Access Compliance Report

Public Rights-of-Way

(Curb Ramps)

Intersection ID: 13302	Main Street: E_4TH_ST	Cross Street: E_JOHN_BELK_RA	Location: E
ADA ID: 1604A79CDBB5	Ramp Type: Directional1	Initial Pass/Fail: Pass	Overall Compliance: No
Severity Score: 0.25			
Codes/Mitigation Info/Possible Solution		Field Measurements/Component Compliance

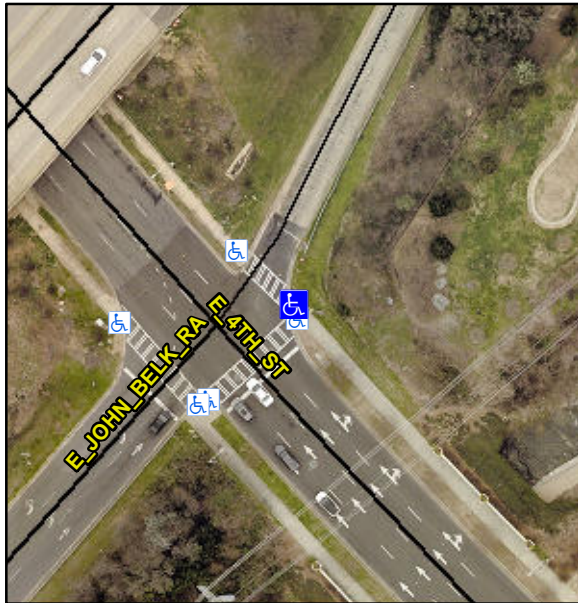
R304.5.3, R207.1

Compliance	Description	Data	Compliance	Description	Data
N/A	Ramp Length (in)	72.0	Yes	Grade Break?	Yes
Yes	Ramp Width (in)	48.0	Yes	Grade Break Slope (%)	4.7
Yes	Ramp Slope (%)	5.7	No	Grade Break XSlope (%)	6.8
No	Ramp XSlope (%)	3.2			
N/A	Flare Type LT	N/A	N/A	Flare Type RT	N/A
N/A	Flare Slope LT (%)	12.1	N/A	Flare Slope RT (%)	9.9
N/A	Flare Traversable LT?	No	N/A	Flare Traversable RT?	No
Yes	Landing Length (in)	62.0	Yes	DWS Provided?	Yes
Yes	Landing Width (in)	99.0	Yes	DWS Contrast?	Yes
Yes	Landing Slope (%)	0.7	Yes	DWS Length (in)	24.0
Yes	Landing X Slope (%)	0.3	Yes	DWS Full Width?	Yes
N/A	Landing Curb? (Y/N)	N/A	Yes	DWS Offset LT (in)	58.0
N/A	Shared Landing?	No	Yes	DWS Offset RT (in)	0.0
Yes	Gutter Ponding?	No	Yes	Gutter Slope (%)	0.2
Yes	Gutter Lip Ht (in)	0.0	Yes	Gutter X Slope (%)	0.9
N/A	Painted X Walk1?	Yes		Road Slope (%)	1.4
	X Walk 1 Direction	To NW		Road X Slope (%)	1.6
	X Walk 1 Width (in)	110.0		Clear Space?	Yes

X Walk 1 Slope (%)	1.4	N/A	Clear Space to XWalk (in)	N/A
	X Walk 1 X Slope (%)	1.6	Yes	Storm Grate/Utility Hazard?	No
No	Ramp inside XWalk1?	No		Storm Grate/Utility Type	
Yes	Any Obstructions?	No			N/A
	Obstruction Type		Yes	Surface Condition? (G/P)	Good
			N/A	Curb Slope (%)	15.3

**Remove & Replace Entire Ramp.
Restripe Crosswalk.**
